Historic Architectural Review Commission
Staff Report for Item 2

To:	Acting Chairman Greg Oropeza and Historic Architectural Review Commission Members
From:	Enid Torregrosa-Silva, MSHP Historic Preservation Planner
Meeting Date:	August 23, 2022
Applicant:	Robert A. Jensen, Owner
Application Number:	H2022-0030
Address:	411 Louisa Street

Modifications to front, side, and rear walls of an existing addition. Second-story addition at rear of property.

Graphic depicting the 1962 Sanborn map and one and a half-story portion of the house over the site's survey.

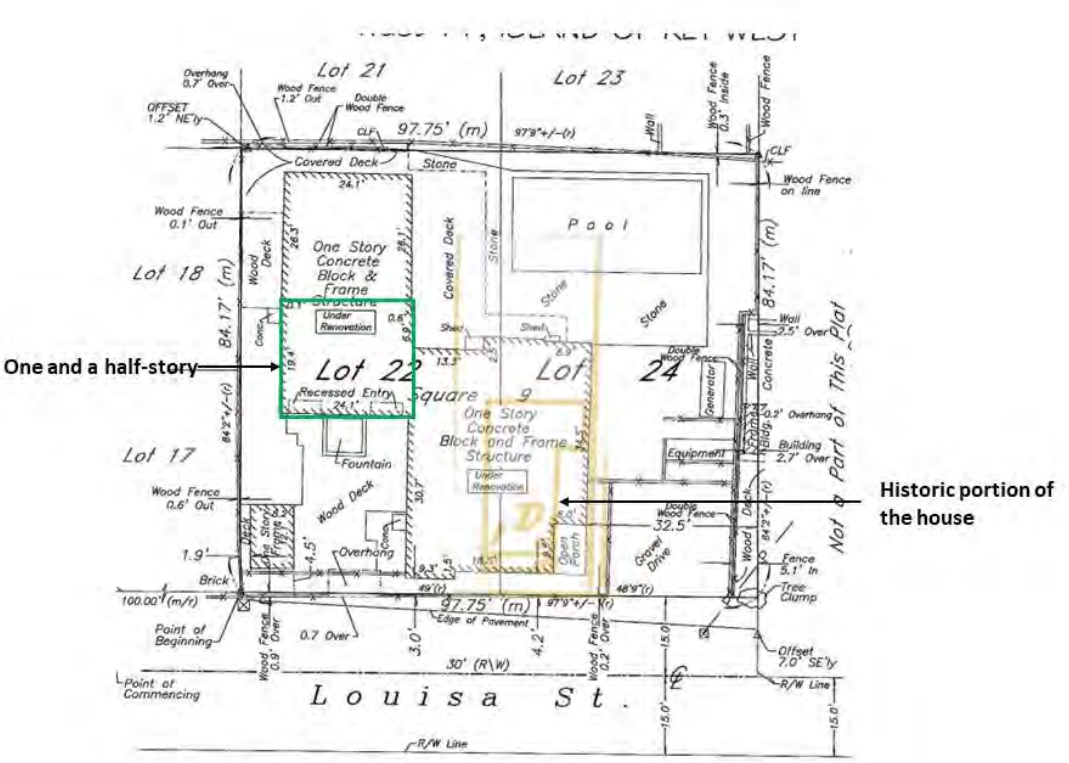
It is staff's opinion that the proposed design fails some of the cited guidelines as the proposed two-story addition increases the scale and mass of an existing large-scale structure. Guideline 13 of additions and alterations states that *new addition massing shall be similar or smaller than the massing found in the existing building and adjacent structures*, and staff opines that the two-story addition is contrary to this regulation. The existing half story is not habitable space and is a dominant element in the residential complex due to its scale. Staff finds that the 5 feet setback of rear yard for a two-story addition will overshadow existing one-story structures adjoining the rear yard and will dominate neighboring properties, which contradicts guideline 12 of additions and alterations.

PROPOSED FRONT ELEVATION

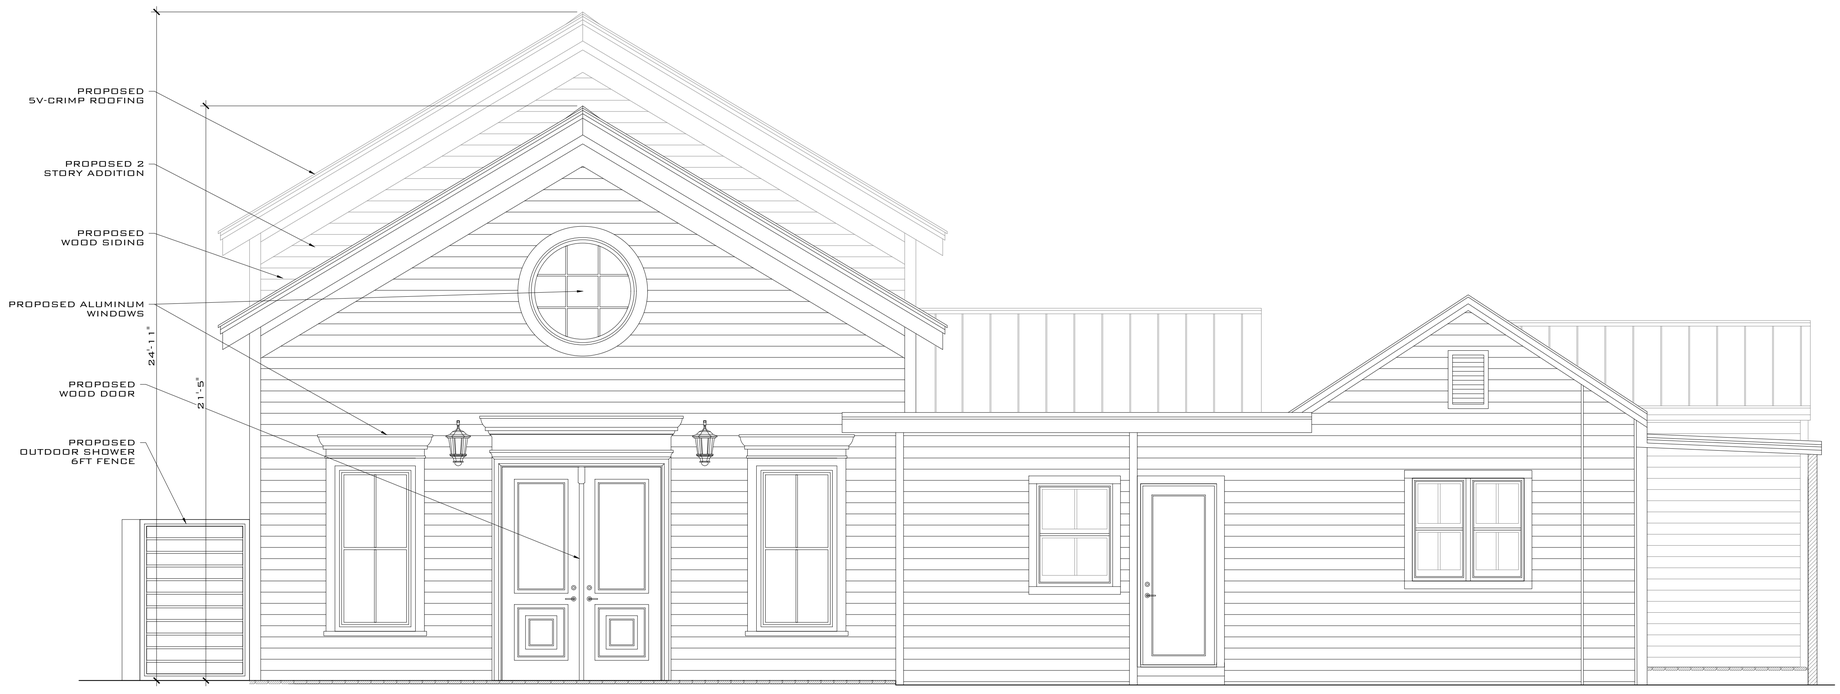
The revised plan still proposes changes to the front elevation which has two recessed entries on the first floor. The plan proposes having the recessed entries flush with the existing façade. New windows will replace existing double doors. One double door will be installed and will replace an existing window. The addition will have wood siding, aluminum windows and doors and 5 v-crimp metal panels for roofing.

For improvements to the front elevation, changes of doors and windows, and maintenance work with siding, staff finds the proposal consistent with cited guidelines. Staff expressed their concerns pertaining mass, scale, and conflicts with the guidelines to the applicant once we reviewed the proposed plans. The applicant has received letters from neighbors in support of this design.

EXISTING LEFT SIDE ELEVATION

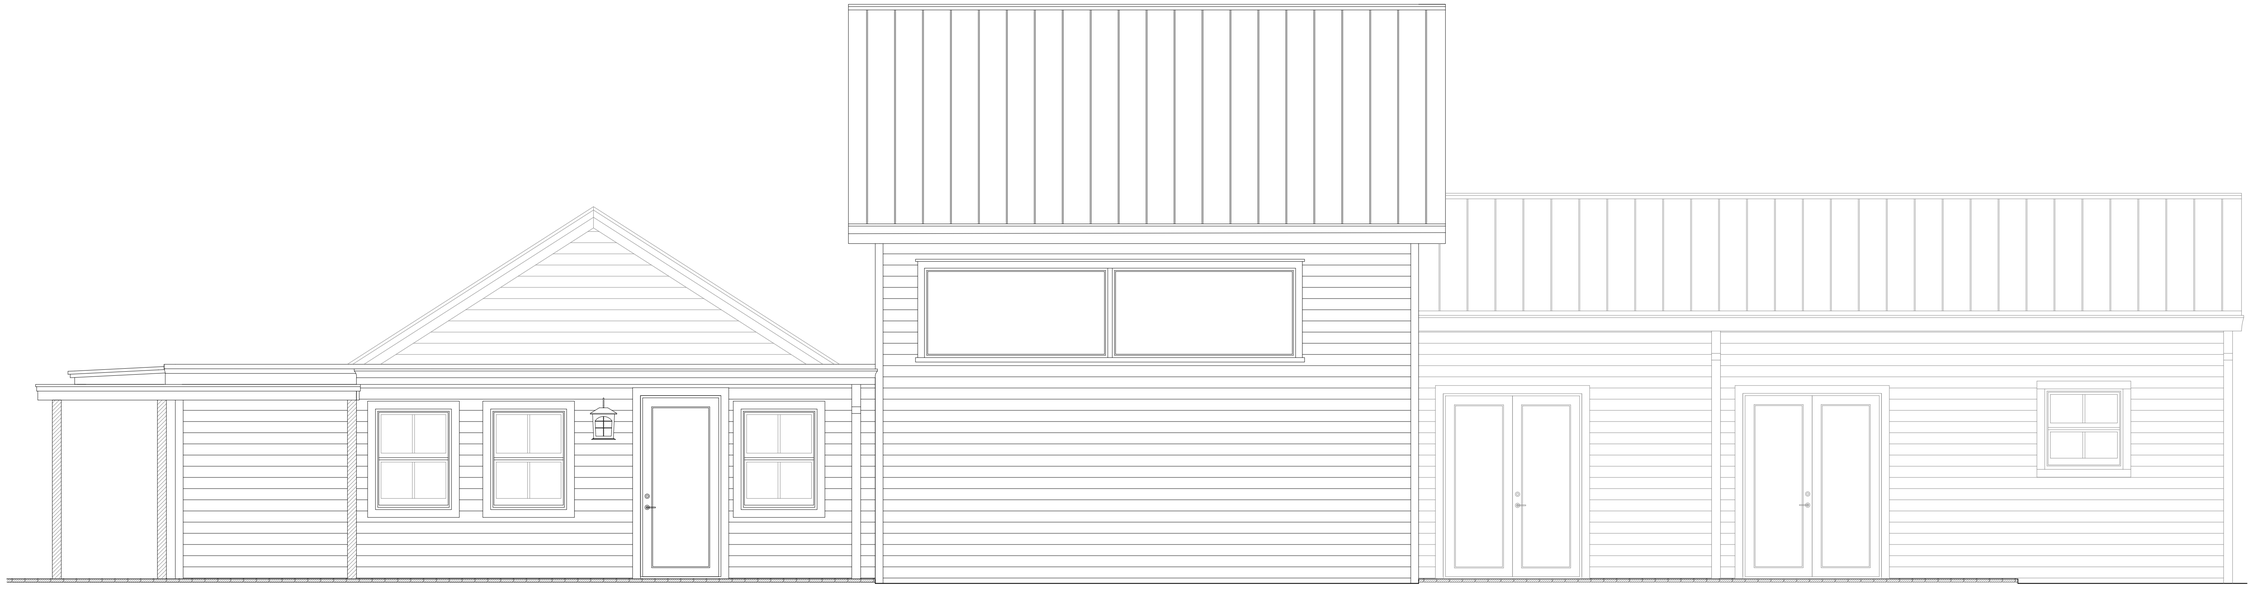
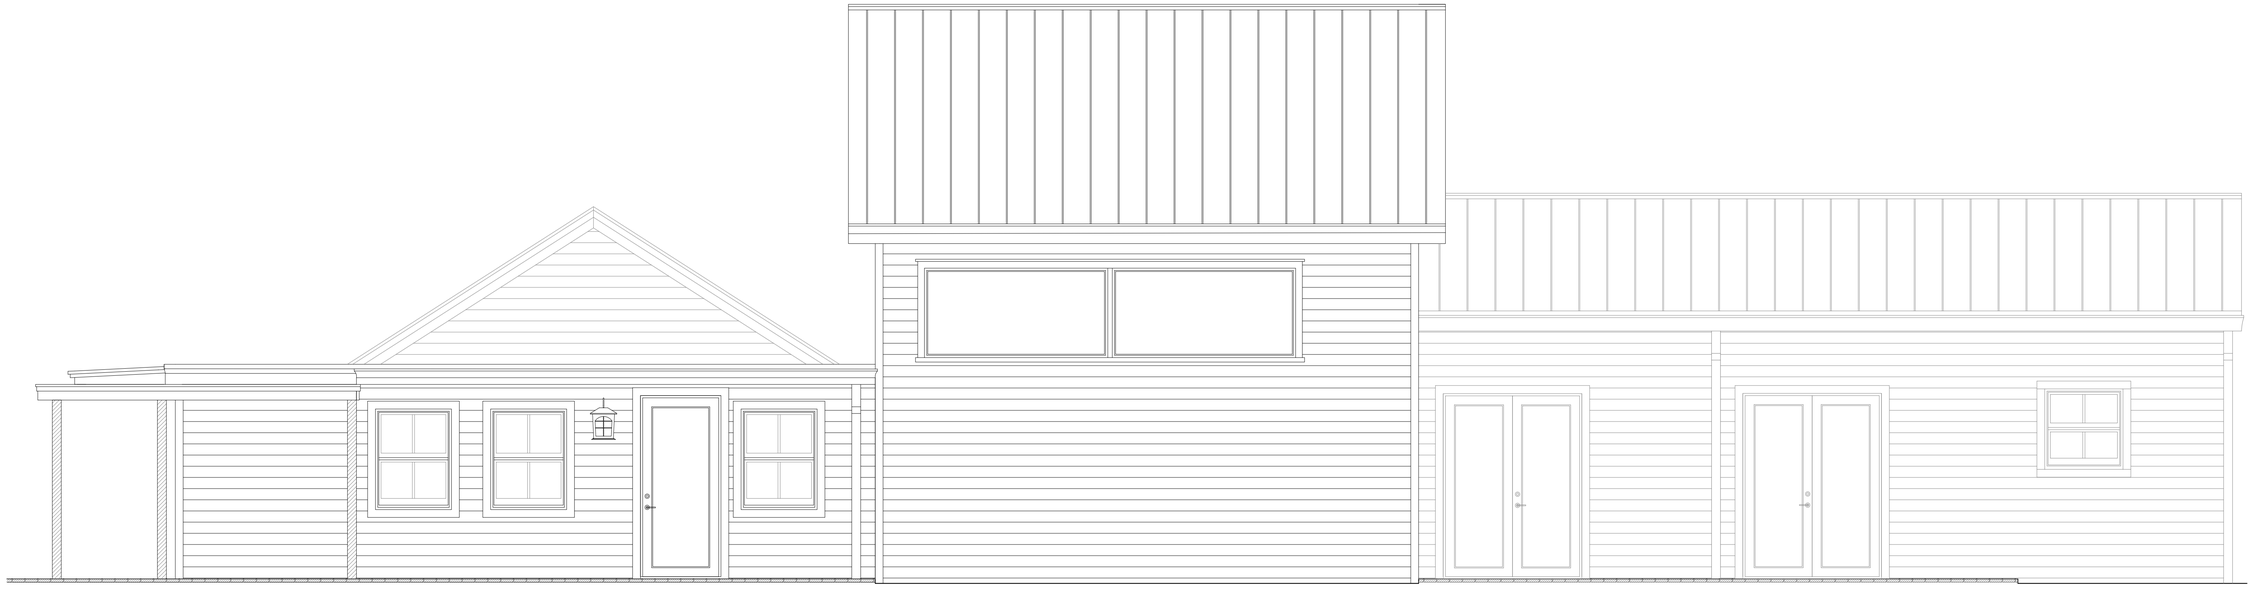
This report is for the review of changes to a previous design that was postponed during the July 27 meeting. The applicant has submitted revised drawings that include decrease of the depth of the two-story addition from approximately 23'- 6" to 22'- 0". Eaves extend approximately 6 inches, which will increase the rear yard setback from 4' to 5'. In addition, the revised plan removed an

exterior shower located on the southwest corner of the two-story addition. Instead sliding doors will give access to an interior shower. The height of the proposed two-story addition will remain to 24'- 11". The proposed addition still includes annotations for wood siding, aluminum windows and doors and 5 v-crimp metal panels for roofing.
